**UNITED STATES OF AMERICA  
NUCLEAR REGULATORY COMMISSION**

**BEFORE THE ATOMIC SAFETY AND LICENSING BOARD**

_____	)	
In the Matter of	)	
	)	Docket Nos. 52-014, 52-015
Tennessee Valley Authority	)	
	)	
(Bellefonte Nuclear Power Plant	)	
Units 3 and 4)	)	
_____	)

**DECLARATION BY DR. ARJUN MAKHIJANI  
REGARDING TVA'S REVISED COST ESTIMATE  
FOR NUCLEAR AND COAL-FIRED GENERATION**

Figure 1: Wind Power Resources in the United States  
Source: National Renewable Energy Laboratory, on the Web at <http://redc.nrel.gov/wind/pubs/atlas/maps/chap2/2-01m.html>

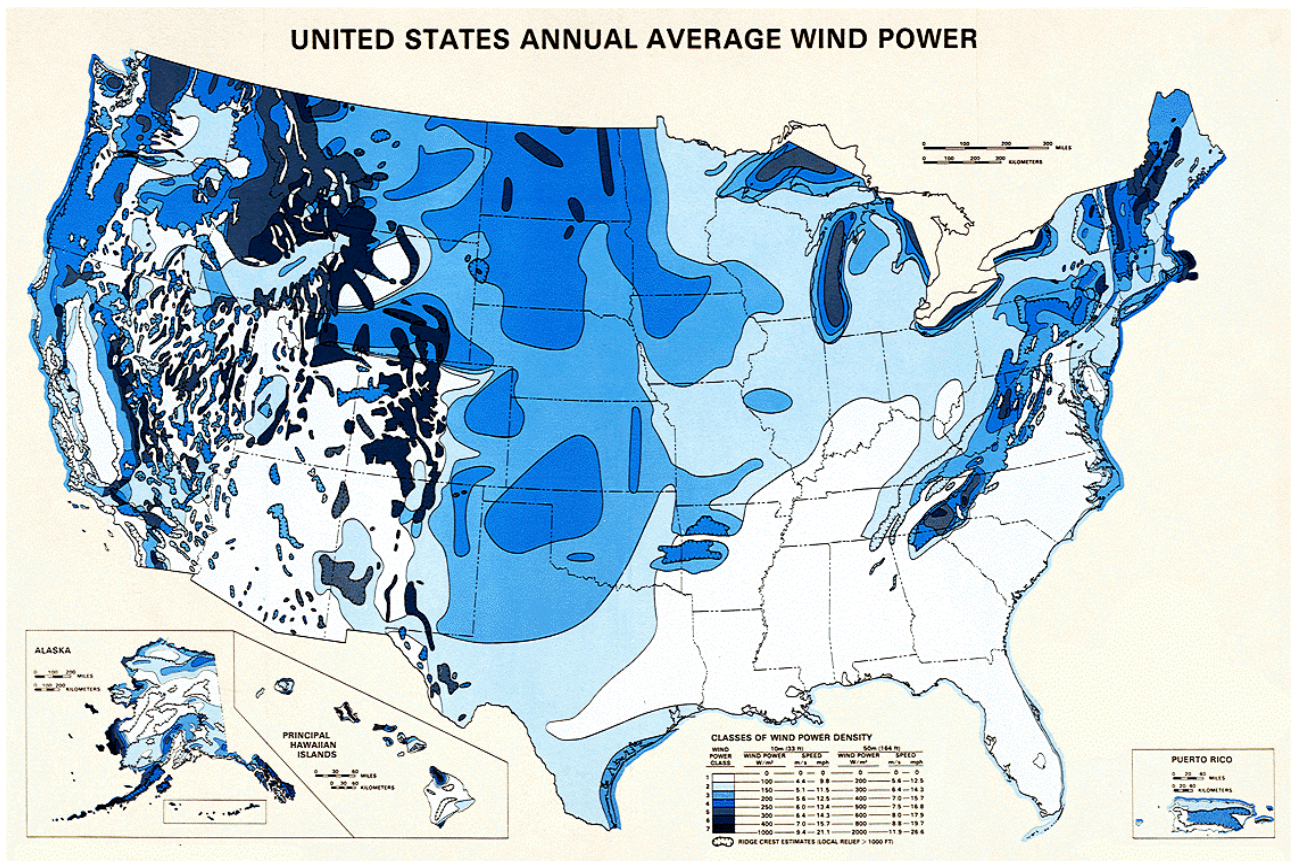
20. Finally, TVA has stated that its region does not have large enough wind resources. This appears to be incorrect, as is indicated by the wind resource map published by the National Renewable Energy Laboratory. As can be seen from Figure 1 below, East

Tennessee has some very good wind resources (the darker shades of blue) over a considerable area. While some have argued that developing wind resources in such areas affects the view, this argument must be weighed against the nuclear waste generated by nuclear power plants, the far larger water use by nuclear power plants, and other similar factors. TVA has not done this. It has rejected the wind resource out of hand as insufficient and not reliable enough. (For the latter point, see paragraph 21 below.) Further, TVA also has the option of signing a Purchased Power Agreement with independent wind development companies, which can benefit from the Production Tax Credit either for wind resources in the TVA region or outside it. For instance, a transmission line from high wind areas in Oklahoma and/or Arkansas (see Figure 1) can be built to carry electricity into the TVA region. For reference, the estimate of connecting windy areas to the grid in Texas for over 18,000 MW of wind (about three times the proposed generation of the two BLN units) would be \$4.9 billion.<sup>32</sup> Given that the total amount of power involved would much smaller than that planned in Texas, TVA transmission lines from high wind areas would likely cost considerably less than the Texas cost cited here. TVA has also done nothing to explore this option.
